Transport for NSW Pre-exhibition Response

Attachment A: Cooks Cove Planning Proposal Pre-exhibition review – Preliminary comments for discussion

Preliminary comments are provided below on the revised draft *Cooks Cove Planning Proposal Transport Impact Assessment* (the revised TIA) dated 22 December 2022, prepared by JMT Consulting, revised intersection design plans dated 21 December 2022, prepared by Arup, the Urban Design and Landscape Report excerpt dated 22 December 2022, prepared by Hassell, and the Letter of Offer dated 21 December 2022 for discussion purposes:

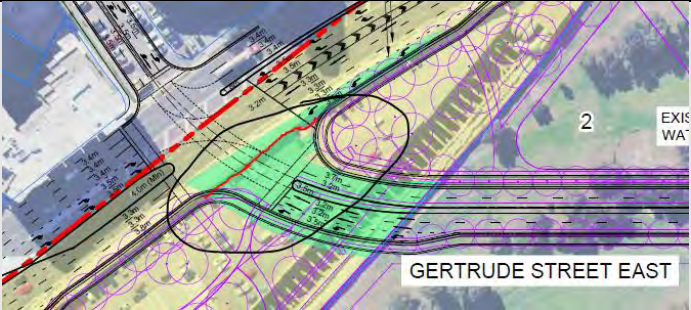
Gateway Determination Requirement 1(a)(i)	<p>The open space design shown to be provided by Bayside Council (Pemulwuy Park South and Pemulwuy Park North) in the Masterplan excerpt conflicts with infrastructure already being provided by TfNSW through the M6 Stage 1 Project, including cycleway and pedestrian infrastructure. The M6 Stage 1 Project has substantially completed design of this area in consultation with Bayside Council. TfNSW requests the cooperation of the developer in resolving any potential conflicts with the objective of doing so without incurring additional cost to the M6 Stage 1 Project.</p>
Gateway Determination Requirement 1(a)(i) & (d)	<p>Condition of Approval E110 of the M6 Stage 1 Project requires the following:</p> <p><i>“Prior to operation of the CSSI, the Proponent must ensure that there is suitable provision for a pedestrian pathway and vehicular access road for council maintenance vehicles to connect Lots 25 and 30 (both identified in the plan set out in Appendix D [of the project approval]) to Marsh Street at Arncliffe. The pathway and access road provisions must meet the reasonable requirements of Bayside Council.”</i></p> <p>Any proposed rezoning and/or reclassification of land must not compromise the ability of the M6 Stage 1 project to comply with this Condition of Approval.</p>
